PROPOSED IMPROVEMENT BRIDGE PROJECT TOWN OF LYNDON COUNTY OF CALEDONIA CENTER STREET (ALT VT 122) BRIDGE #2 CLASS II MAJOR COLLECTOR

PROJECT LOCATION LYNDON BHO 1447(26)

RECORD PLANS

CONTRACTOR: AUTIN CONSTRUCTION, INC. - CONCORD, VT
RESIDENT ENGINEER: DOUG BUMPS
CONSTRUCTION BEGAN: APRIL 15, 2004
CONSTRUCTION COMPLETE: JULY 6, 2005
RECORD PLANS BY: DOUG BUMPS & CHIP PIERCE

PIER NO. 2 PLAN
SCALE: 1/4" = 1'-0"

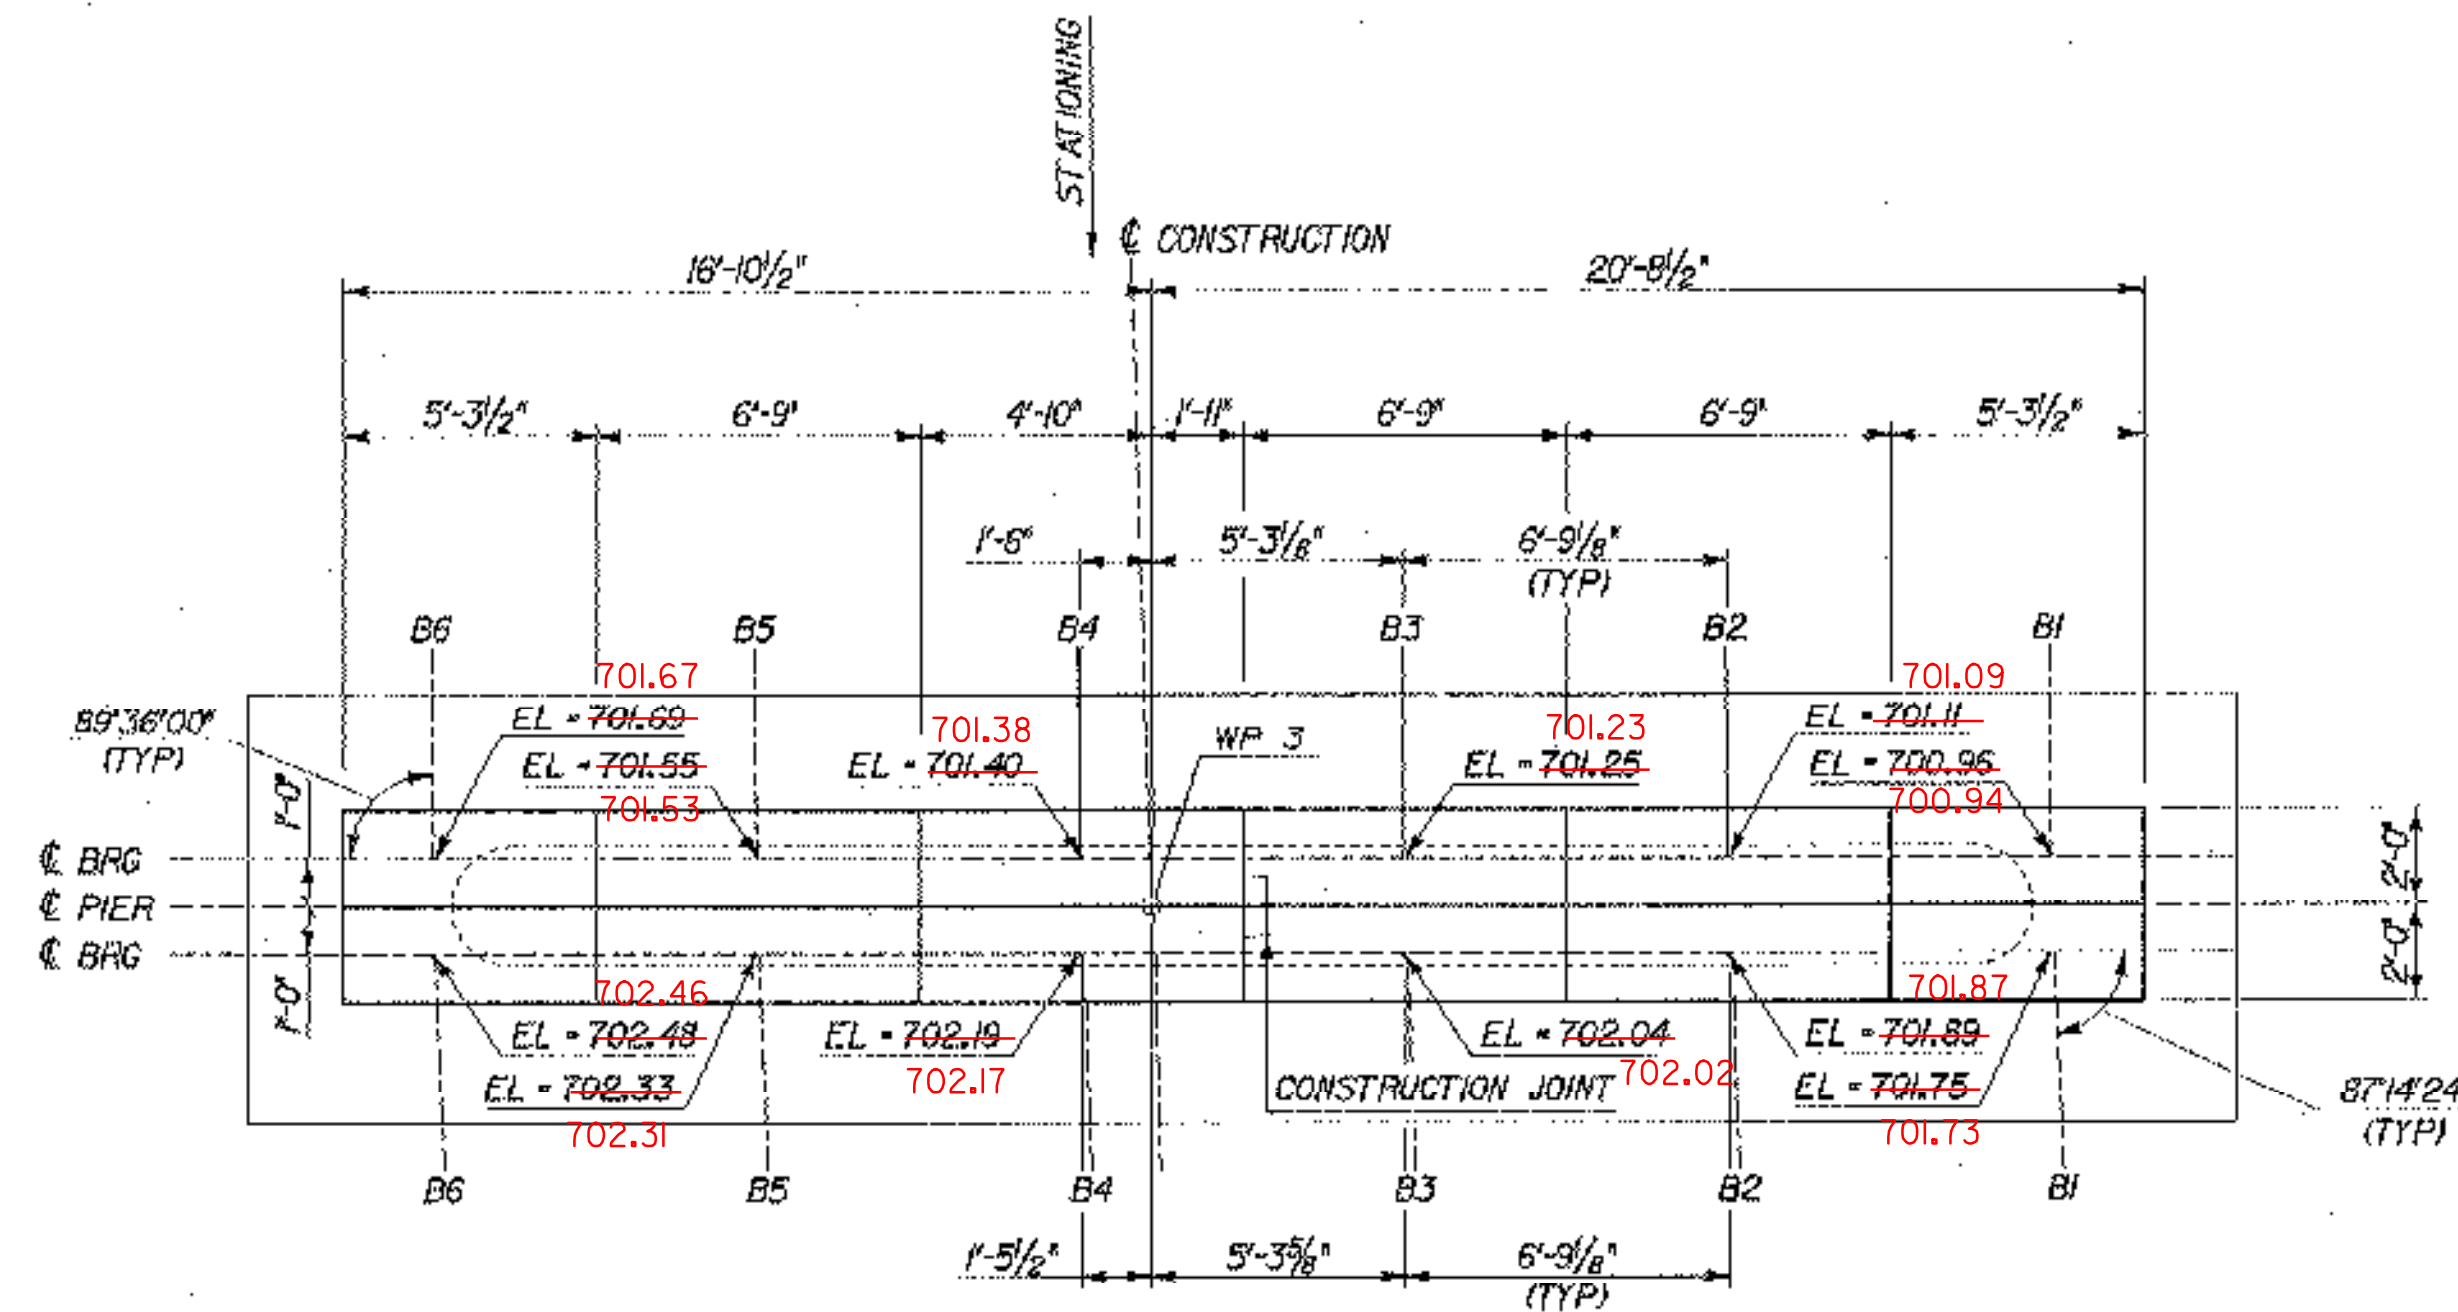
SEAT GRADES
ADJUSTED IN FIELD
TO FIT EXISTING
ABUTMENT GRADES
